Red-Line Revision 1

MD 146 (Dulaney Valley Road) @ Fairmount Avenue

#### TRAFFIC SIGNAL PLAN

TS NO. 1927D DRAWING - OF SHEET NO. 1 OF 4

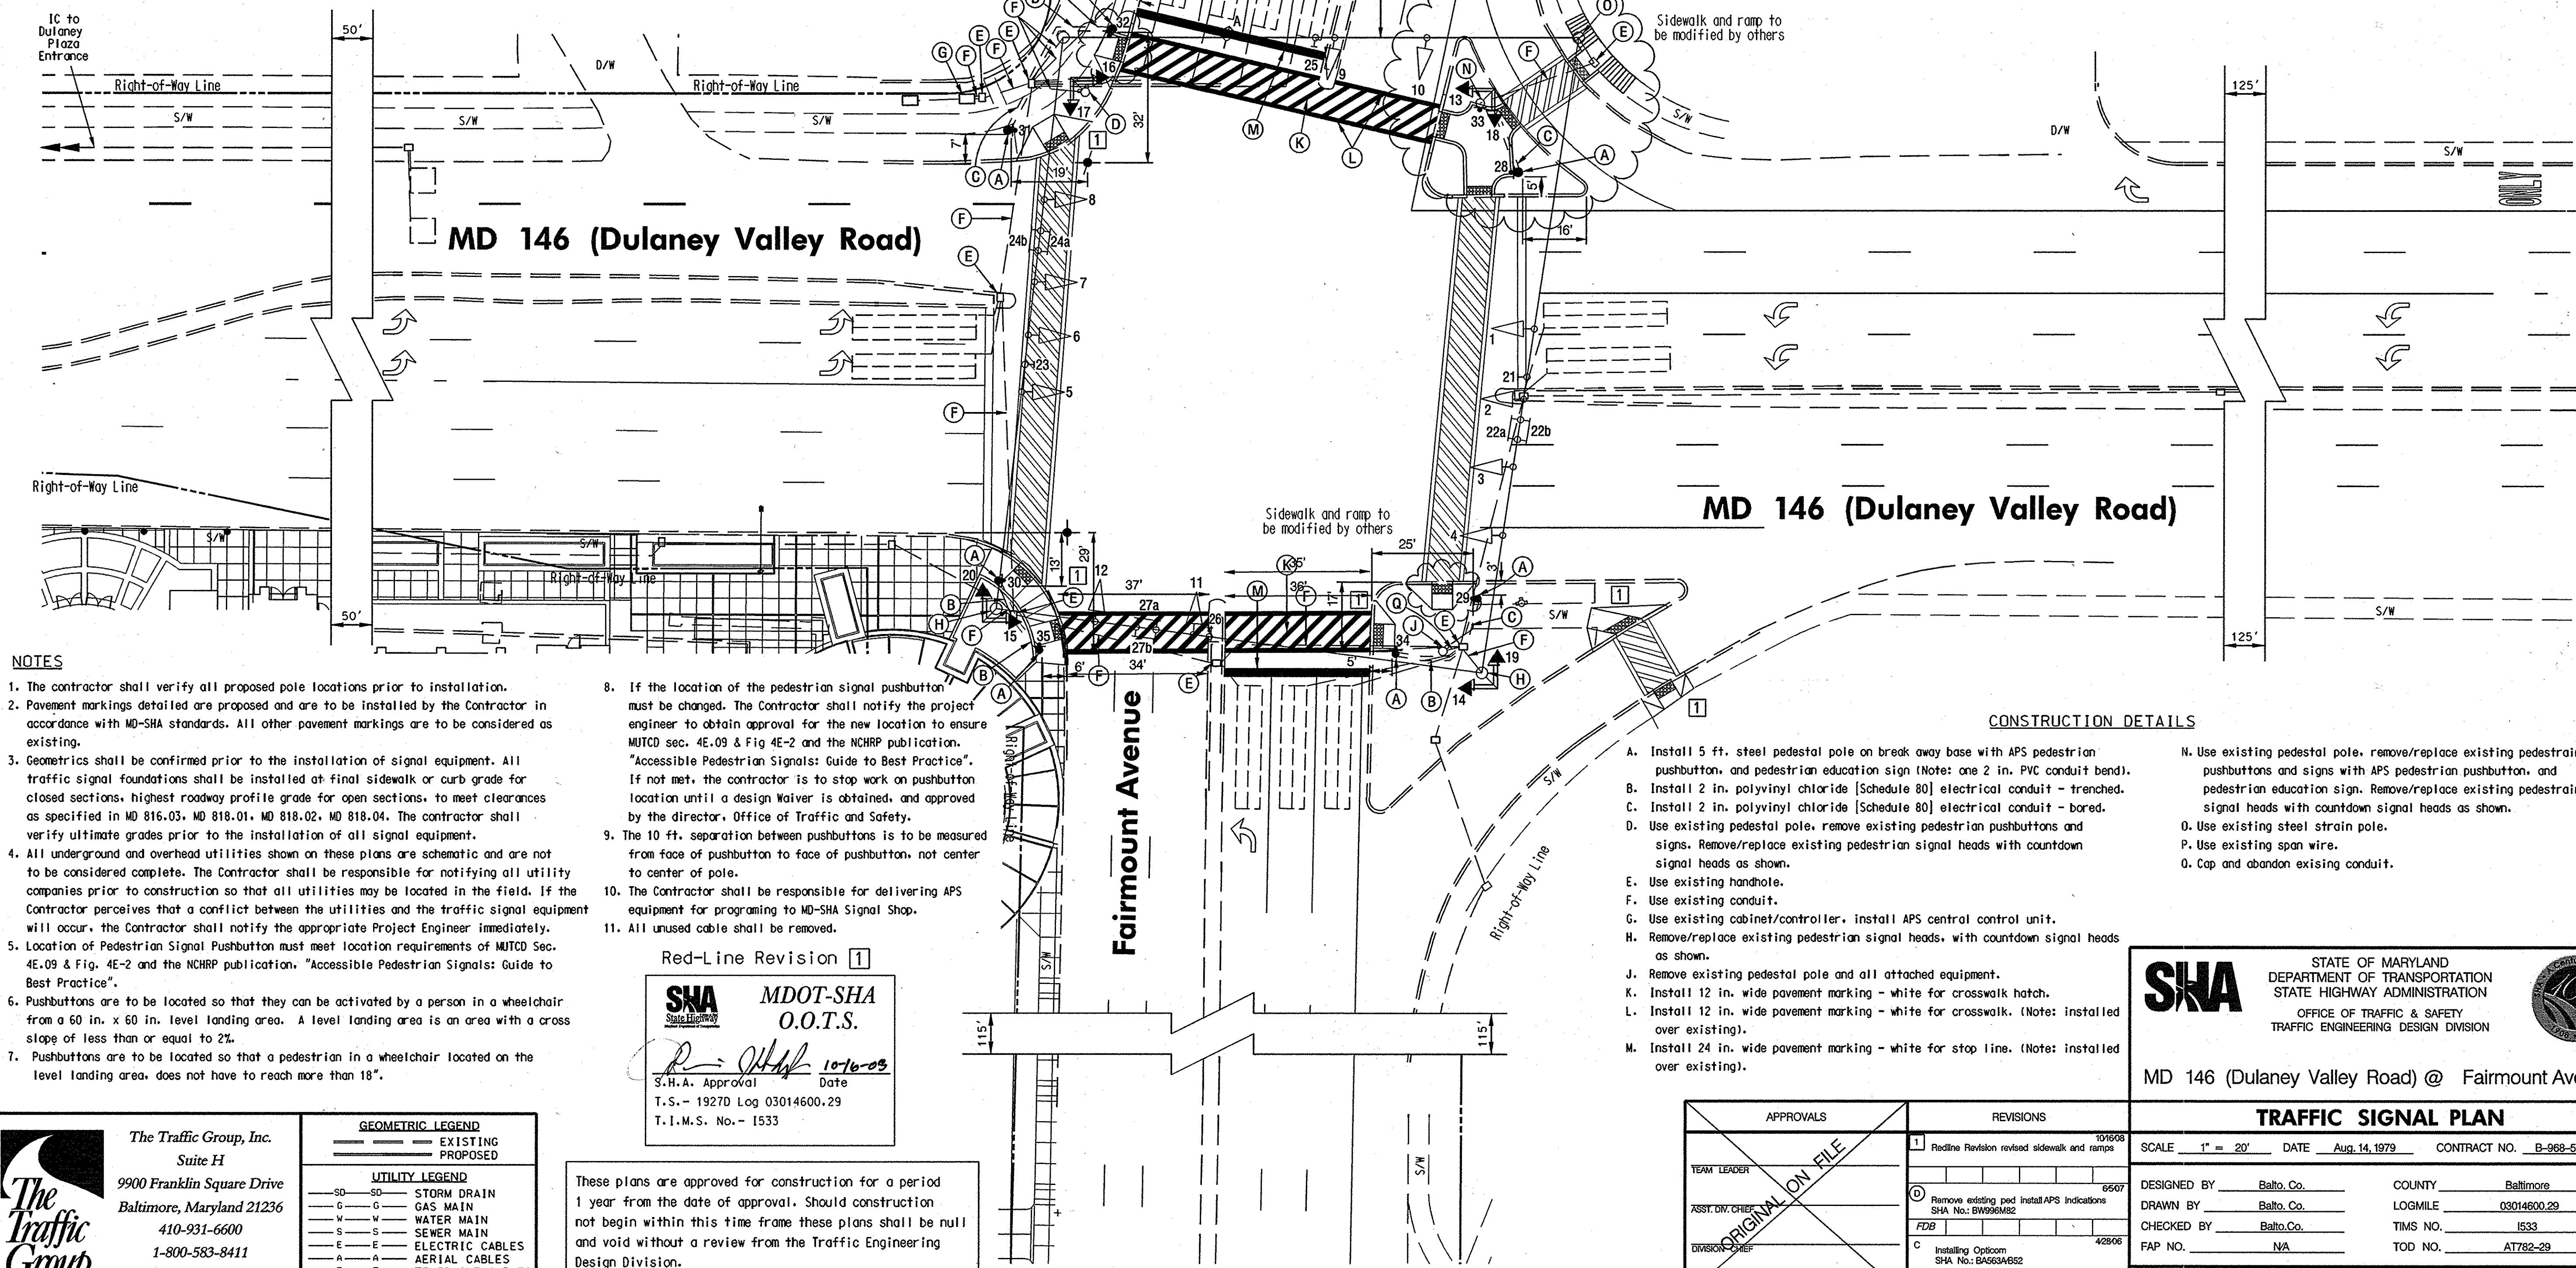
- A. Install 5 ft. steel pedestal pole on break away base with APS pedestrian pushbutton, and pedestrian education sign (Note: one 2 in. PVC conduit bend).

- D. Use existing pedestal pole, remove existing pedestrian pushbuttons and signs. Remove/replace existing pedestrian signal heads with countdown signal heads as shown.

- I. Remove existing pedestal pole and all attached equipment.
- J. Install 12 in. wide pavement marking - white for crosswalk hatch.
- K. Install 12 in. wide pavement marking - white for crosswalk. (Note: installed over existing).

- L. Install 24 in. wide pavement marking - white for stop line. (Note: installed over existing).
- M. Use existing pedestal pole, remove/replace existing pedestrian pushbuttons and signs with APS pedestrian pushbutton, and pedestrian education sign. Remove/replace existing pedestrian signal heads with countdown signal heads as shown.
